ADDENDUM NO.1

RFB - 927940-03

WRC Fire Alarm Phase 4

Project: 9279.40 BI#03 Fire Alarm Phase 4

1 FIRST FLOOR - FIRE ALARM RENOVATION PLAN
1/8" = 1'-0"

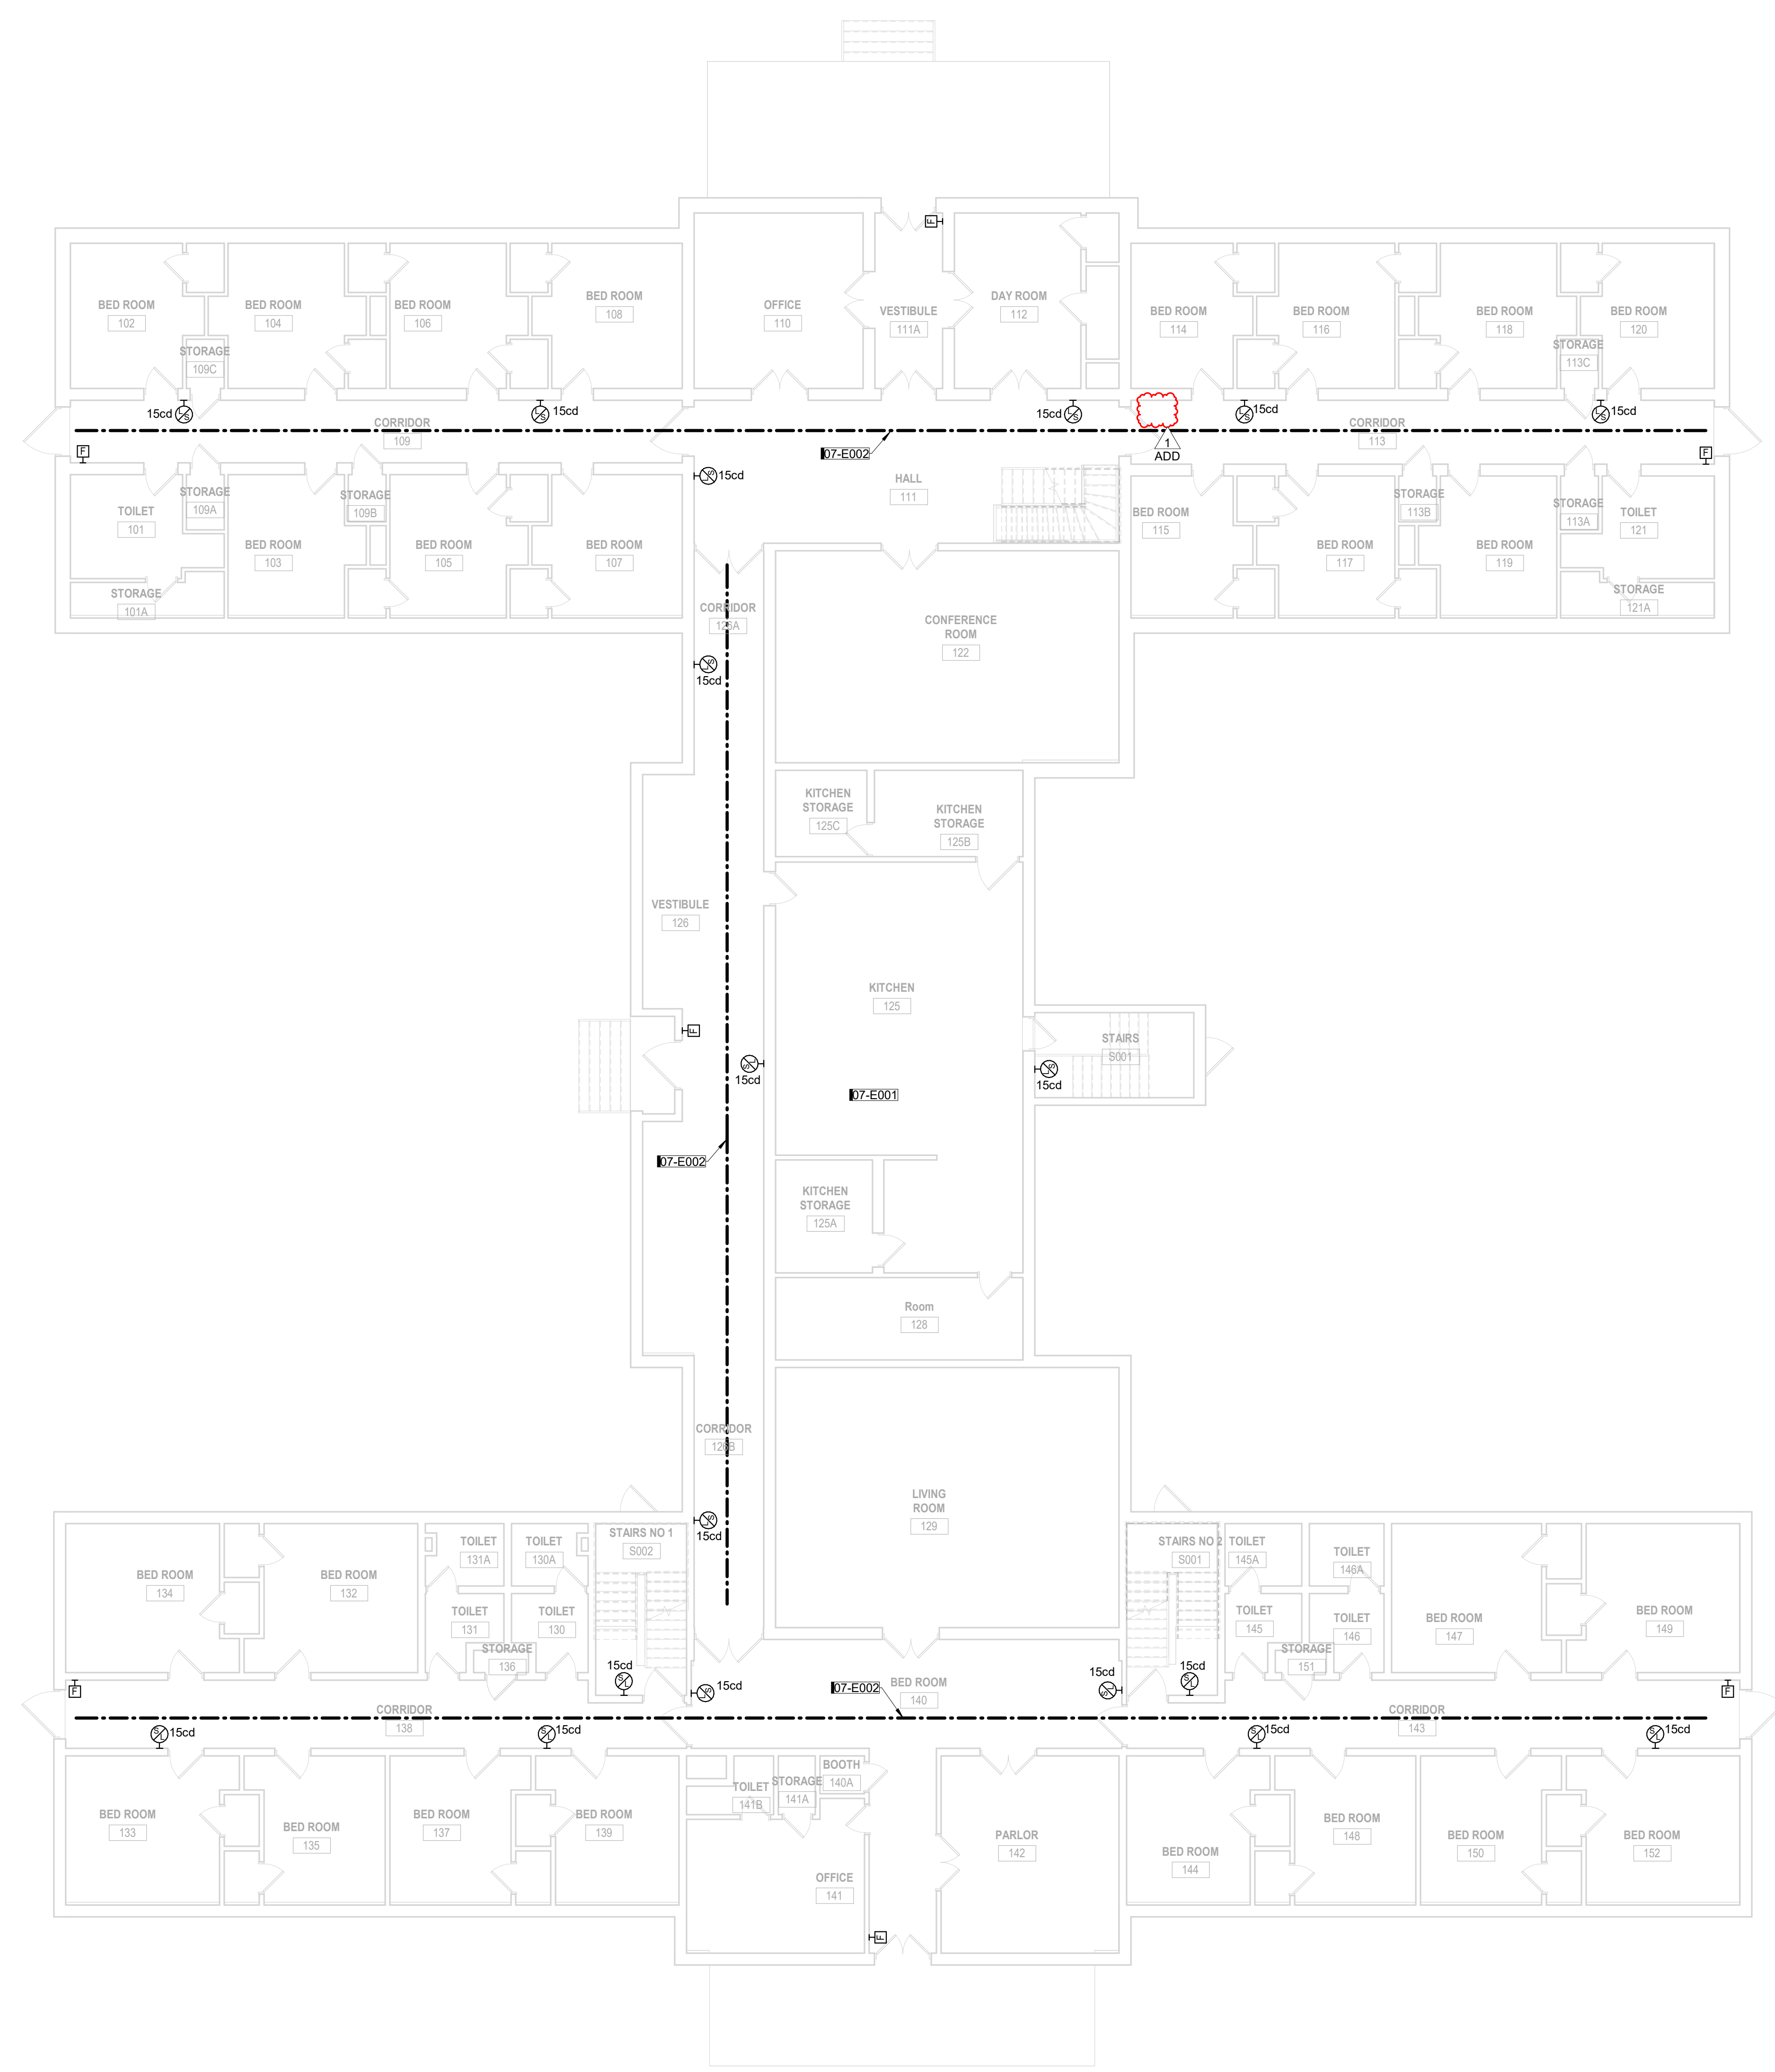
11. On page 07-E01 top of page is a new door hold, I assume this is not needed and just did not get removed from the demo drawings? Can you please confirm.
 - A) Door holder will be removed from the drawings. Refer to clouded drawings in the Addendum #1

KEYNOTES	
07-E001	FIRE ALARM IN EMPLOYEE HOME CONNECTED TO FIRE ALARM CONTROL PANEL IN MYERS HALL. ROUTE FIRE ALARM CABLING BETWEEN BUILDING VIA NEW CONDUIT. REFER TO 00-G002 FOR CONDUIT ROUTING. FIRE ALARM ANNUNCIATION ONLY TO ACTIVATE IN THE BUILDING WHERE DETECTION DEVICE IS ACTIVATED.
07-E002	LINEAR HEAT DETECTOR WIRE.

1 SECOND FLOOR - FIRE ALARM RENOVATION PLAN
1/8" = 1'-0" 0' 12"

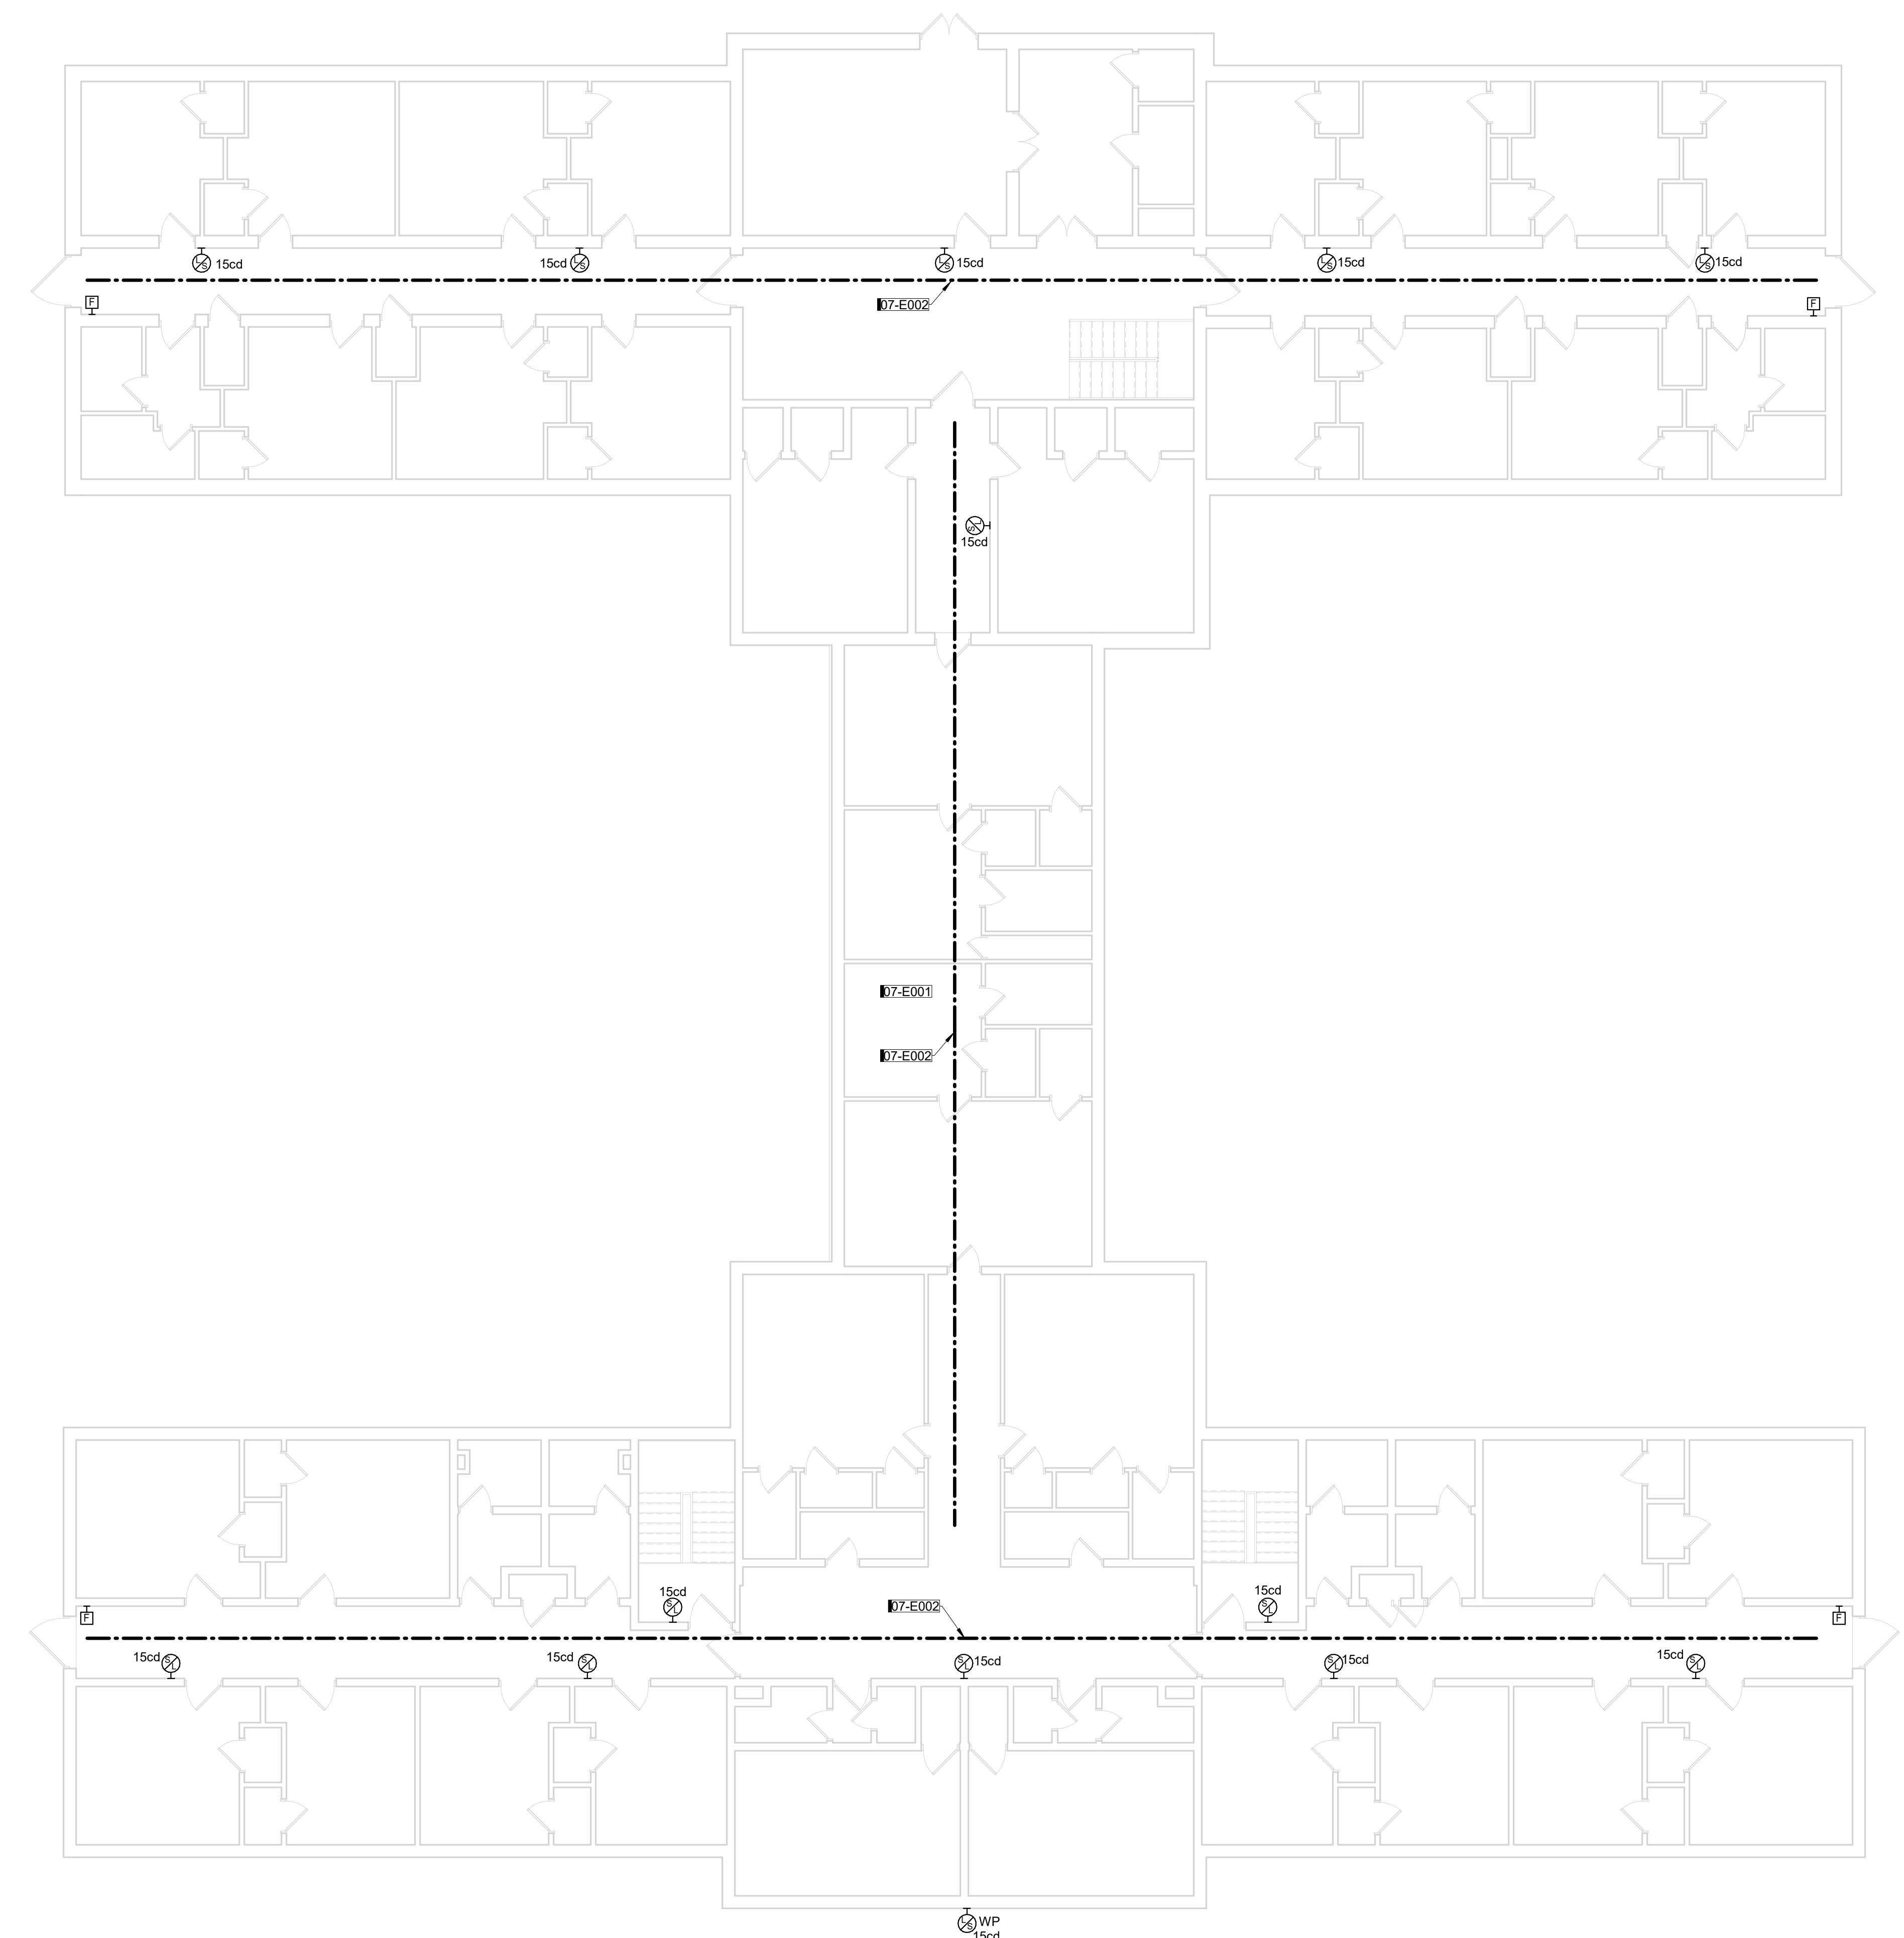
4. How should linear heat detection wiring be installed in areas without ceilings compared to areas with ceilings?
 - A) 00-E000. Refer to clouded drawings in the Addendum #1.

KEY	NOTE
ADD 07-E001	FIRE ALARM IN EMPLOYEE HOME CONNECTED TO FIRE ALARM CONTROL PANEL IN MYERS HALL. ROUTE FIRE ALARM CABLING BETWEEN BUILDING VIA NEW CONDUIT. REFER TO 00-G002 FOR CONDUIT ROUTING. FIRE ALARM ANNUNCIATION ONLY TO ACTIVATE IN THE BUILDING WHERE DETECTION DEVICE IS ACTIVATED.
ADD 07-E002	LINEAR HEAT DETECTOR WIRE.

08-E300

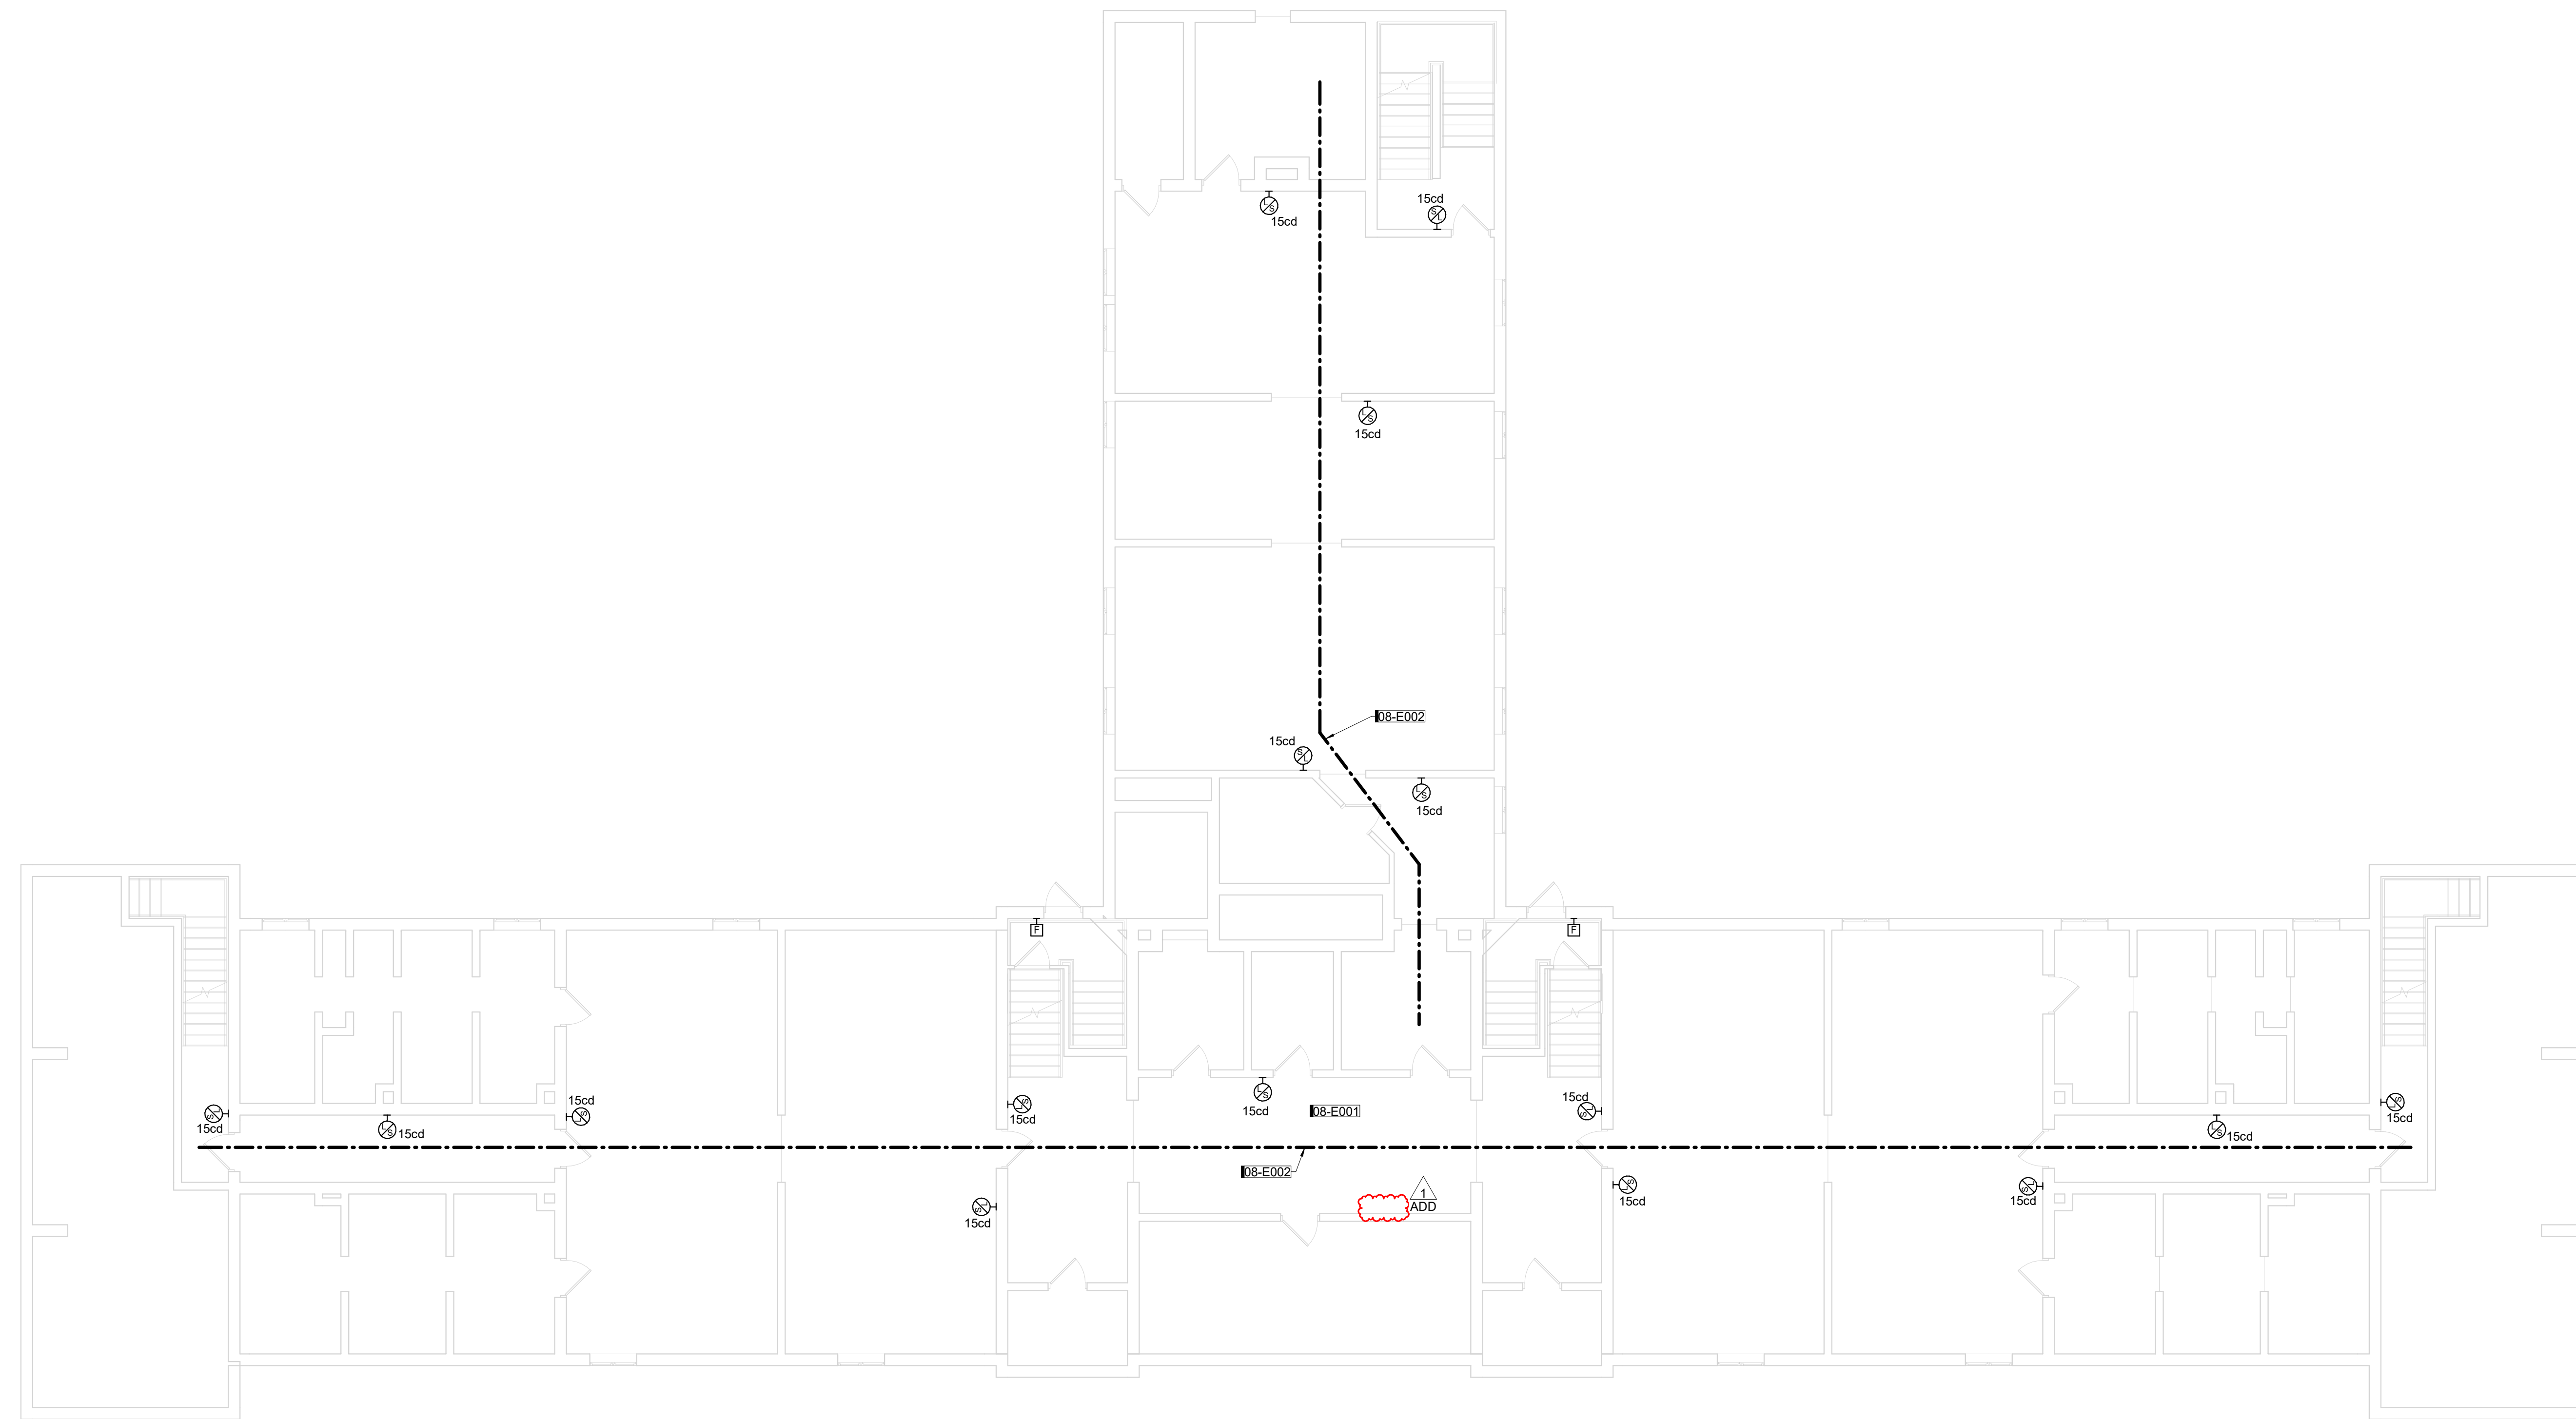
6. Maple Lodge drawings show a new FACP in the basement; however, that building is abandoned. Is the FACP still required to be installed?
 - A) No. A revised drawing sheet will be issued in Addendum #1.

KEYNOTES	
KEY	NOTE
08-E001	FIRE ALARM IN MAPLE LODGE CONNECTED TO FIRE ALARM CONTROL PANEL IN CAMPUS FOOD SERVICE BUILDING. ROUTE FIRE ALARM CABLING BETWEEN BUILDING VIA EXISTING TUNNELS THAT CONNECT THE BUILDINGS. REFER TO 00-0002 FOR CONDUIT ROUTING. FIRE ALARM ANNUNCIATION ONLY TO ACTIVATE IN THE BUILDING WHERE DETECTION DEVICE IS ACTIVATED.
08-E002	LINEAR HEAT DETECTOR WIRE.
